TORNADO BASEBALL MOD FOR 215A PROGRAM CARD

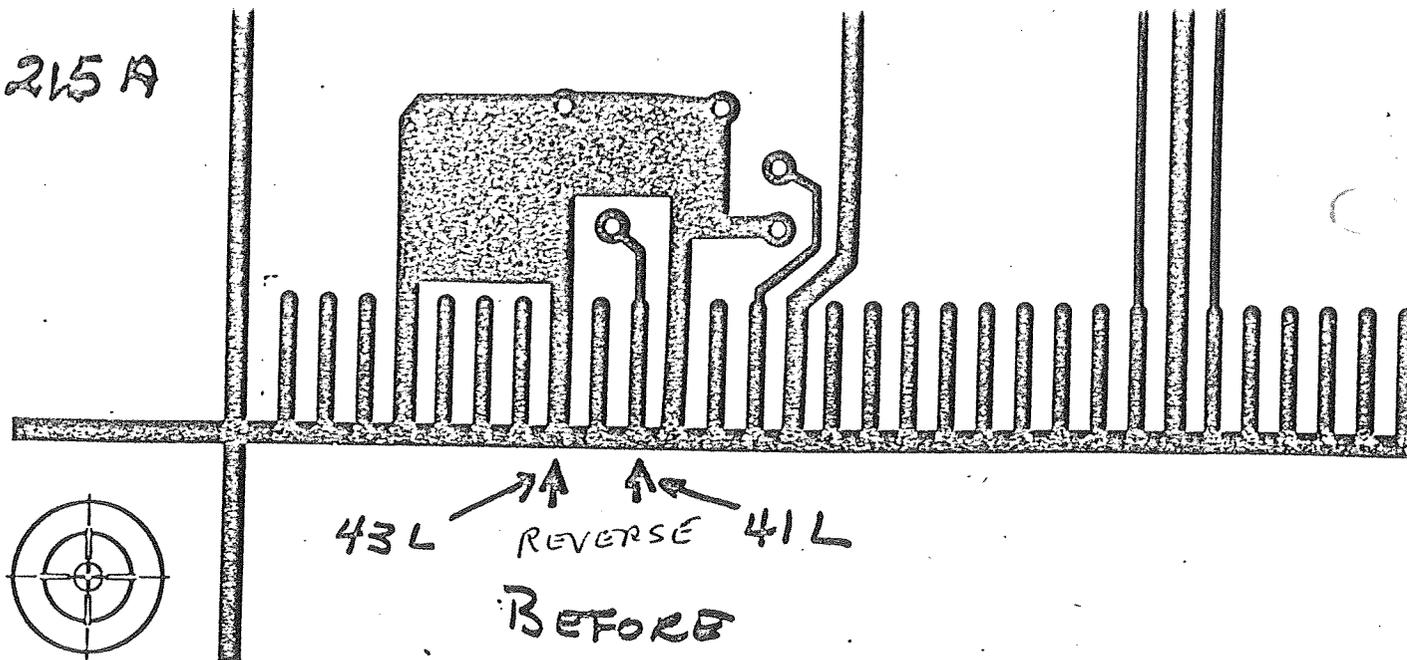
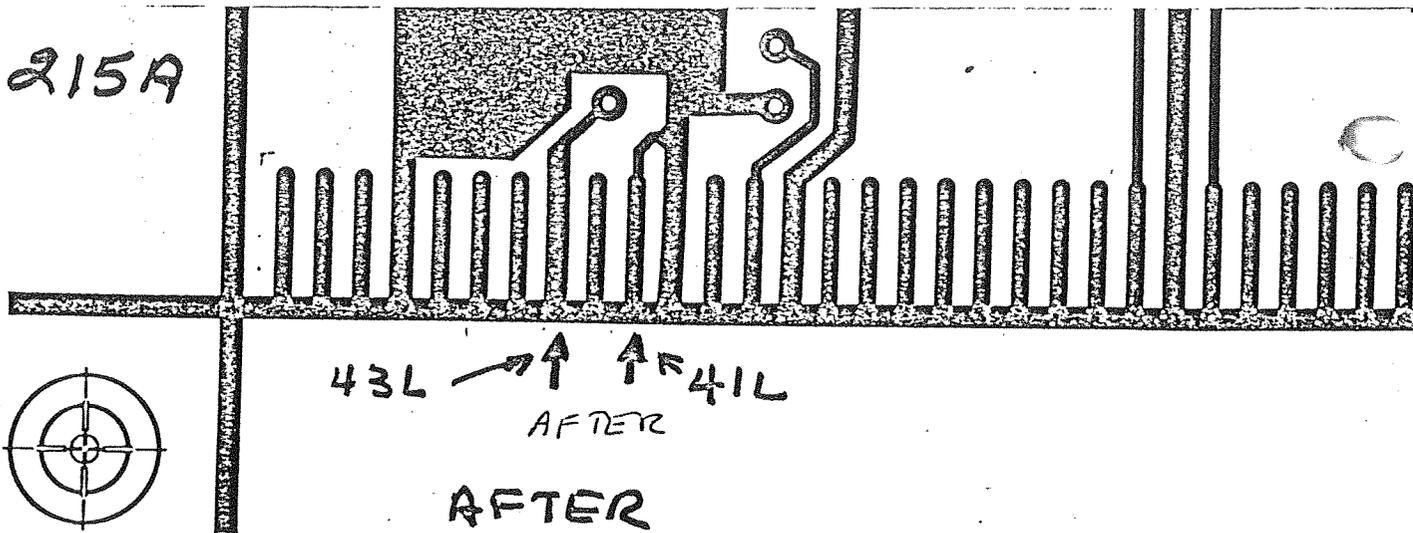
PROBLEM: Fielders will not move to right when SR7 is pushed.

CORRECTION: Cut 43 lower loose from GND and connect this point to hole directly above 43 lower. Cut 41 lower loose from this hole and connect to GND.
